# CAIRNCROSS WASTE MANAGEMENT FACILITY – RESPONSE TO SUBMISSIONS REPORT APPENDIX A

## AMENDED PROPOSAL DESCRIPTION

06 DECEMBER 2018

Figure 1-2 Proposed landfill layout and stages (Stage 1)

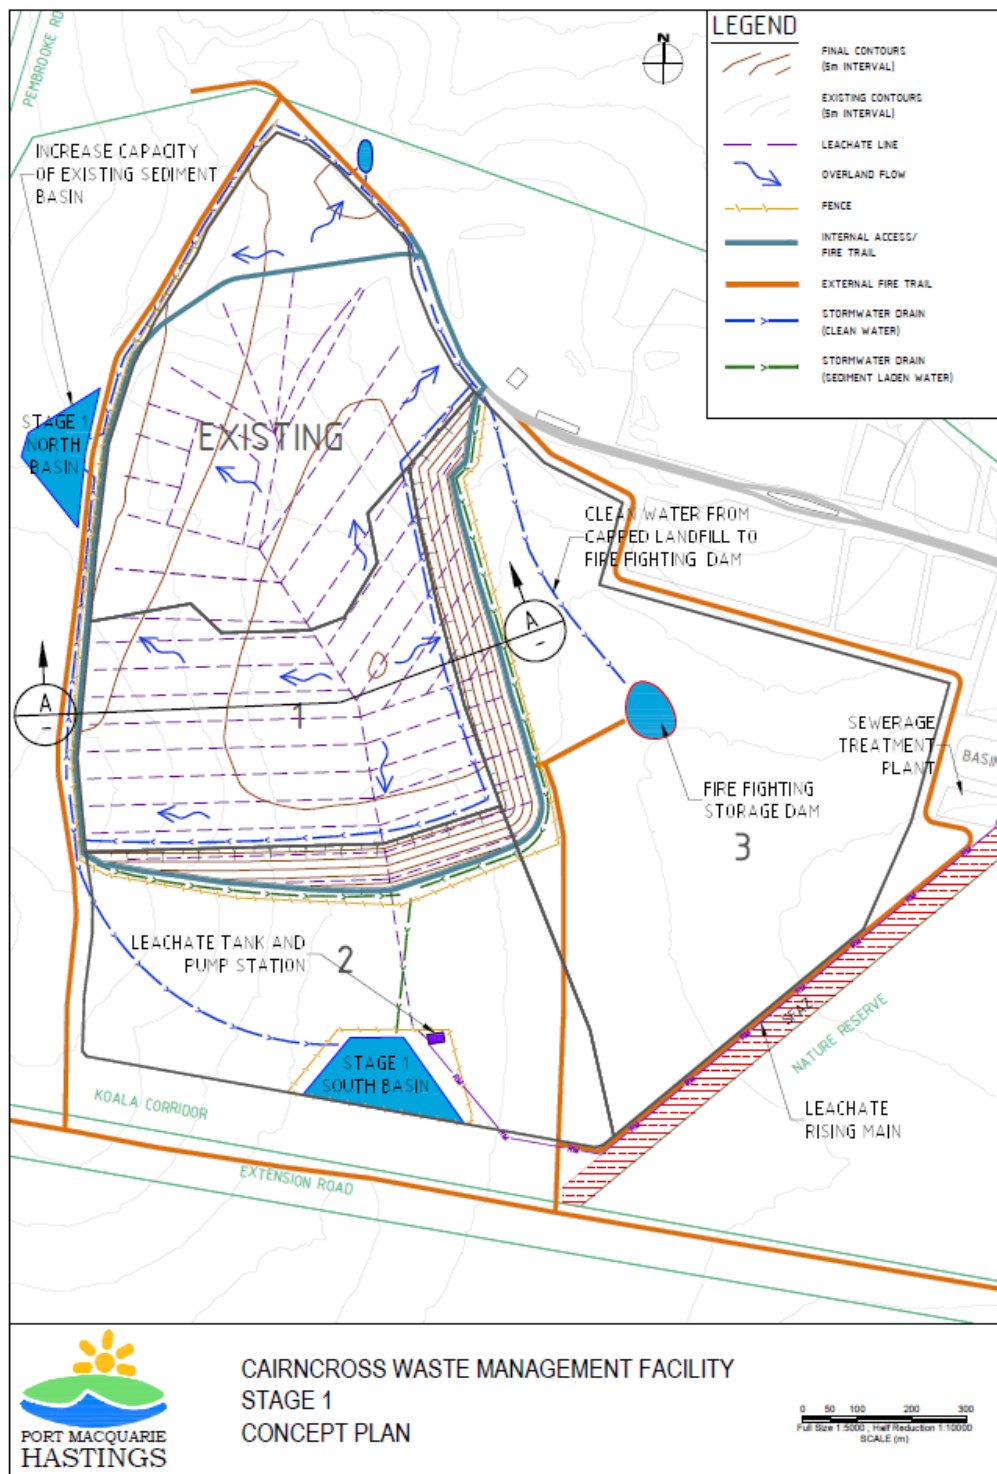
The staging boundaries have also been modified to allow for an approximately 50 metres wide Koala corridor to allow for the movement of Koalas in the south-east to the north-west of the site (see Figure 1-2 and Figure 1-12).

Chain wire fencing will be installed around the active landfill stage. The Koala corridor will remain unfenced until Stage 2 is developed, at which time a fence will be installed between the Stage 2 area and the Koala corridor. **Fencing is depicted on Figure 1-2 to Figure 1-4.**

Figure 1-10 Areas where maximum groundwater levels are above the landfill floor level

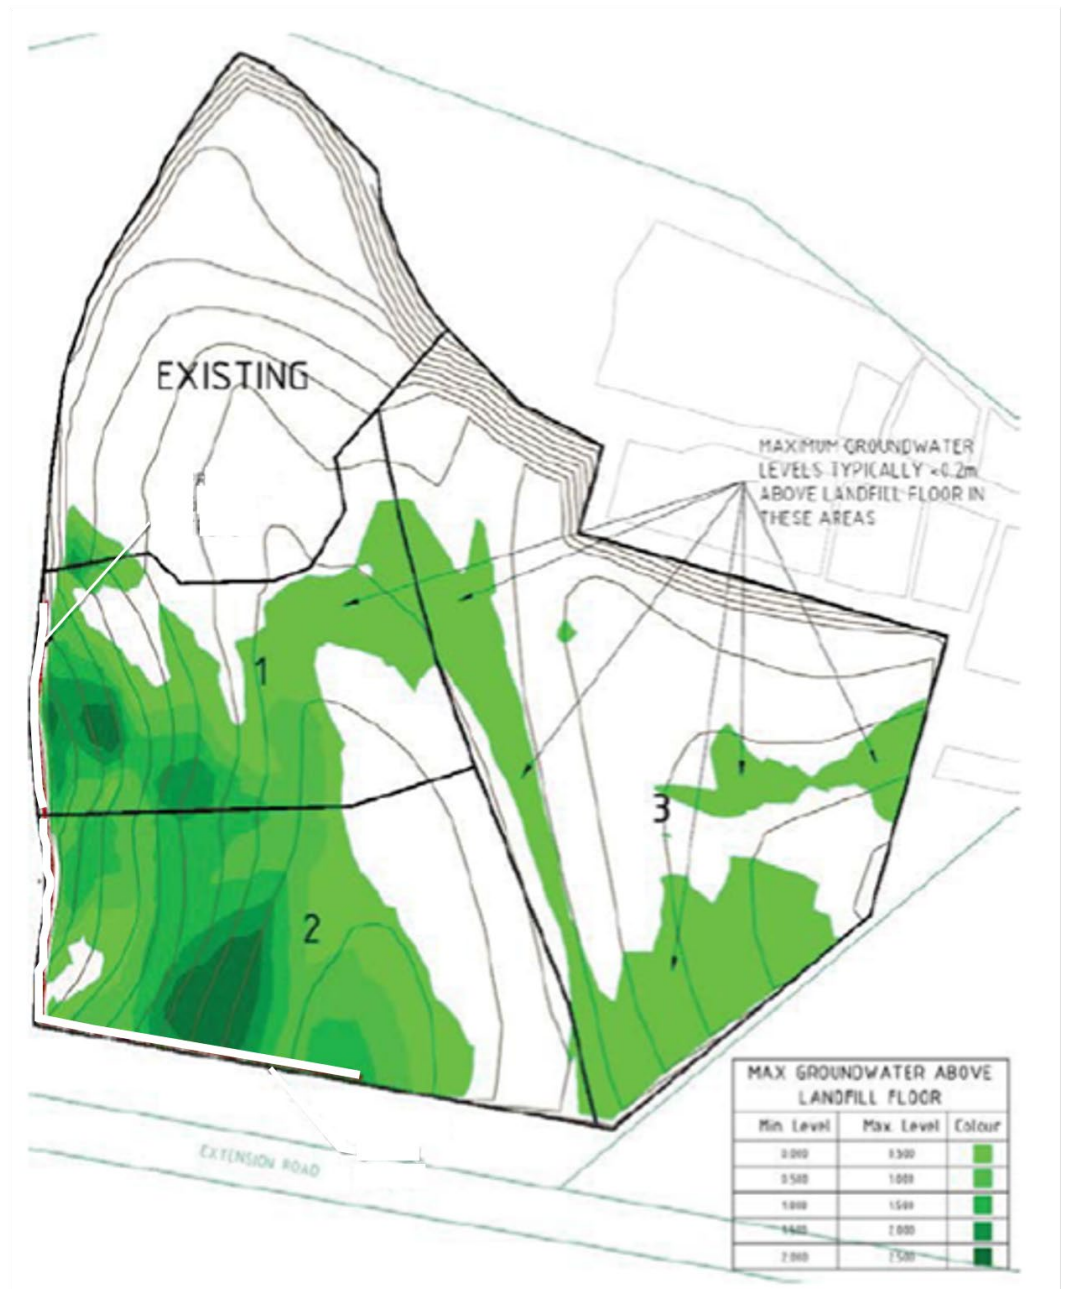
Figure 1-8 shows the estimated depths and locations where groundwater may be encountered by the landfill excavation. ~~In order to avoid any risk of groundwater infiltration into the landfill cells, a gravel/rubble trench is proposed around the perimeter of the landfill at locations where groundwater may be encountered (Figure 5-8). The gravel trench will drain to the landfill low point at the southern perimeter, and prevent groundwater from entering the landfill cell during excavation and filling operations. The gravel trench is to remain operational following the closure of the landfill to prevent groundwater impacting the closed landfill.~~

To avoid any risk of groundwater infiltration into the landfill cells, a groundwater collection system will be installed between the base of the landfill liner and the final excavation layer. The groundwater collection system is described in detail in Appendix C of the RtS. In summary it would comprise the following key elements:

**Figure 1-12 Landfill base typical cross section**

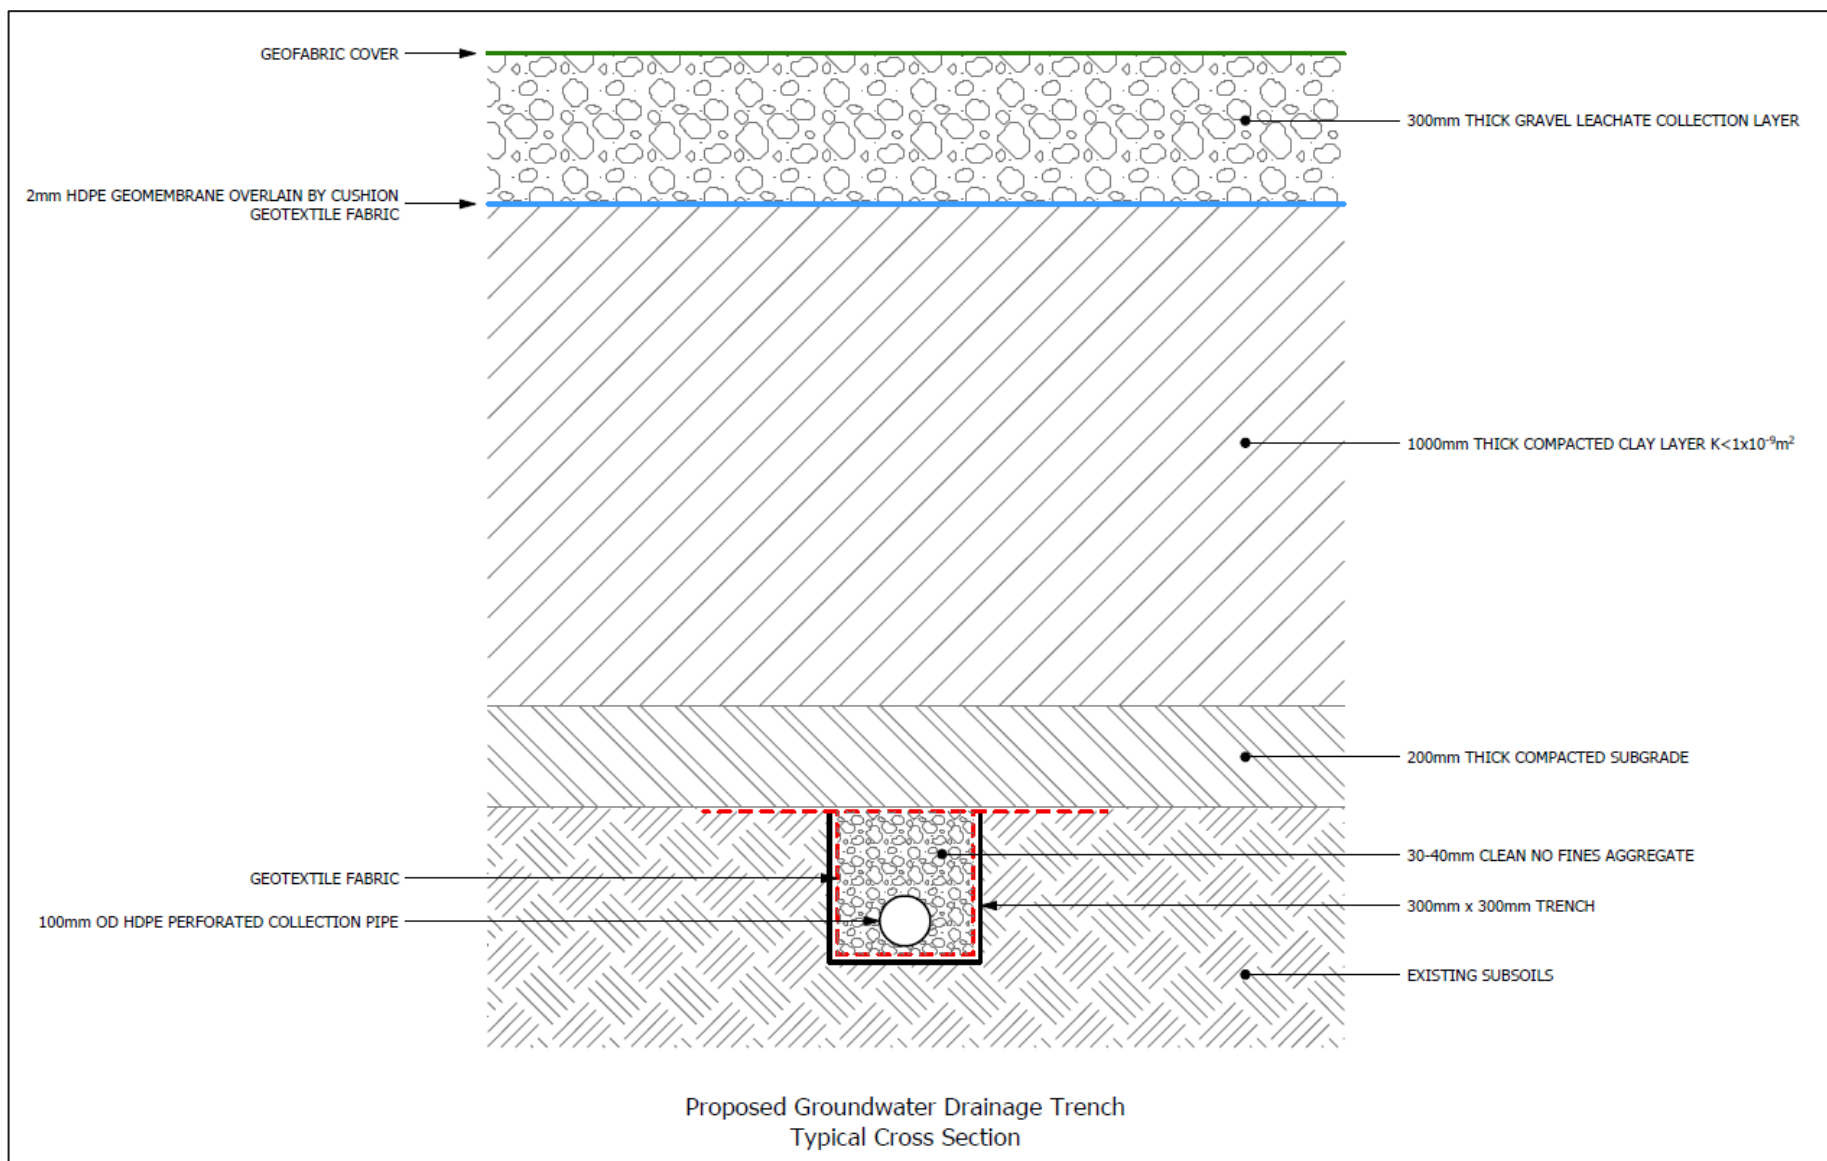
The purpose of the collection/drainage layer would be to manage groundwater inflow rates and resulting hydrostatic upward pressure under the predicted maximum potentiometric head conditions. The most likely design option for the collection/drainage layer is through the installation of collection trenches containing a high-permeability granular material and perforated pipework (refer to Figure 1-10 below). A herringbone pattern of trenches would use gravity to drain the groundwater to a main header pipe and sump system for extraction. Further design detail of the drainage layer is provided in Section 6 of this RtS.

**Figure 1-14: Stage 2 & 3 Boundary Typical Cross Section**

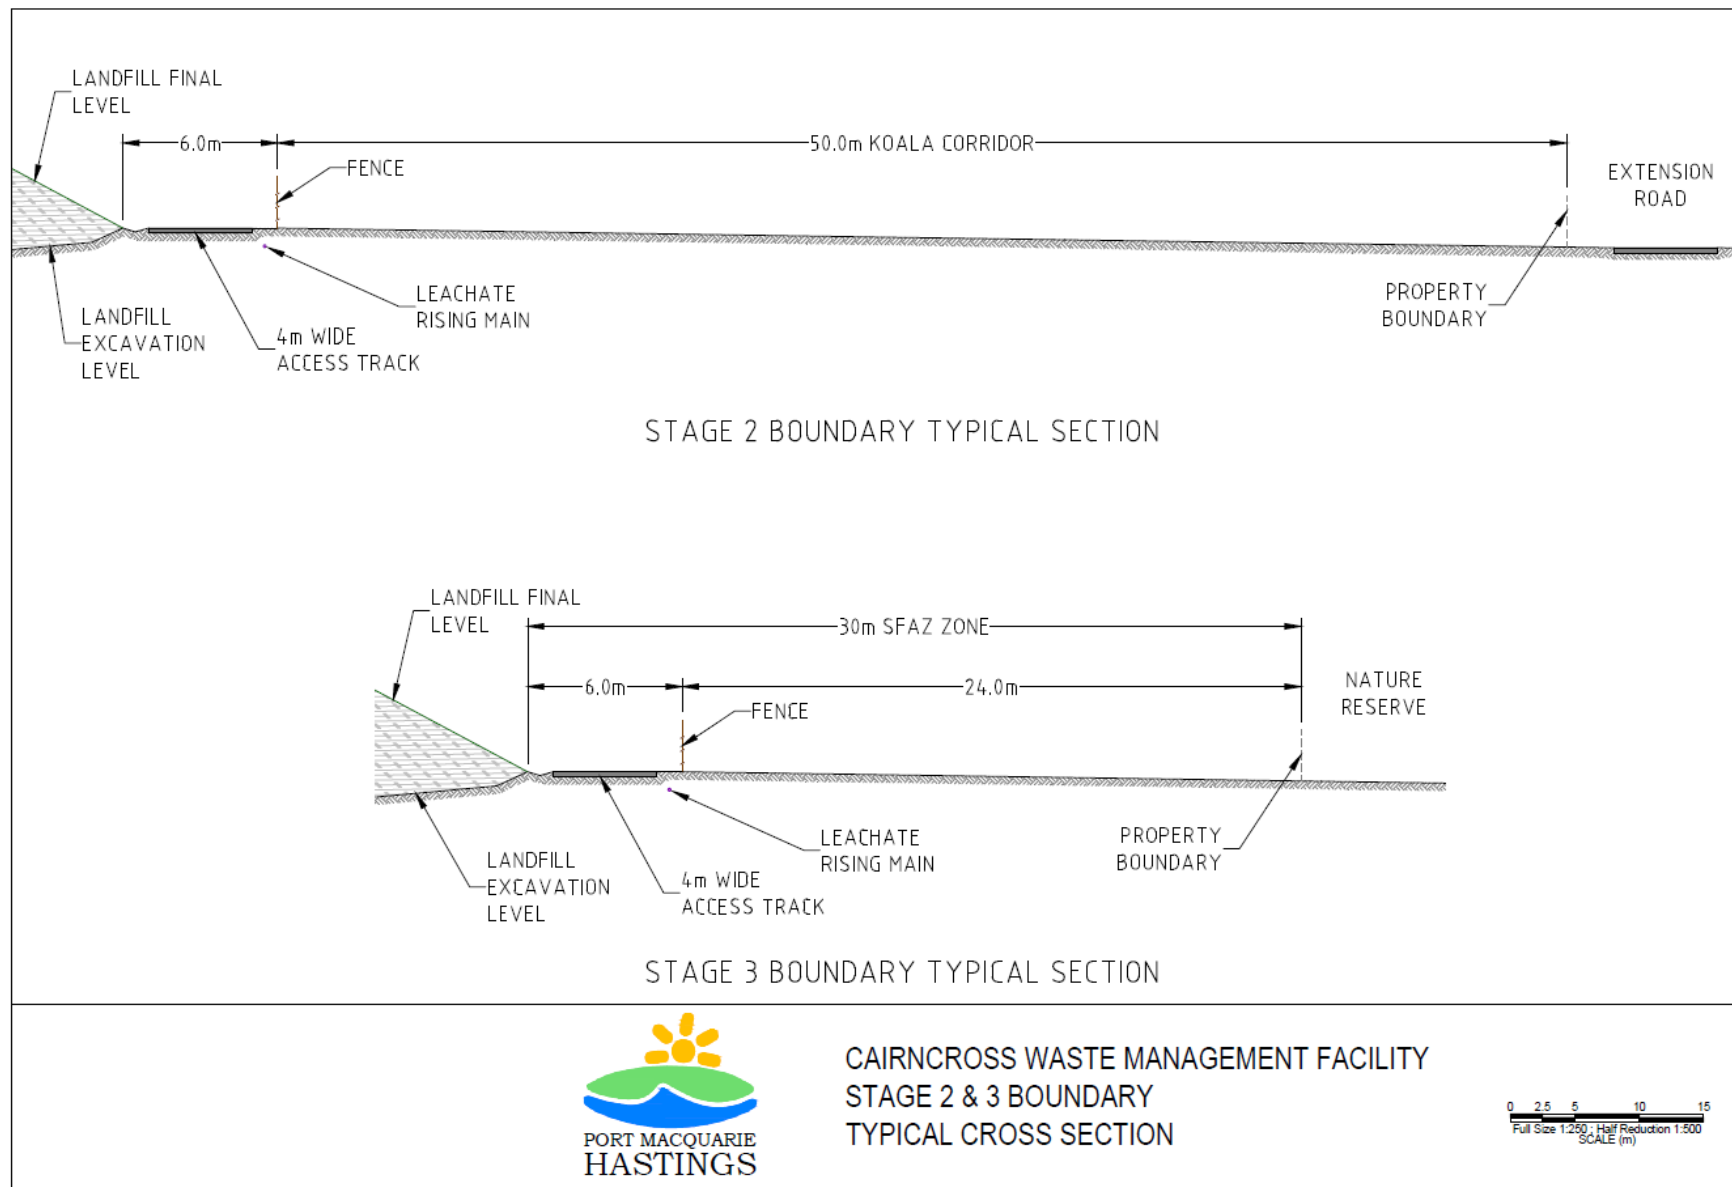
**A typical cross section of access roads and the SFAZ (and Koala Corridor) along the Stage 2 and 3 boundaries is provided in Figure 1-12 below.**
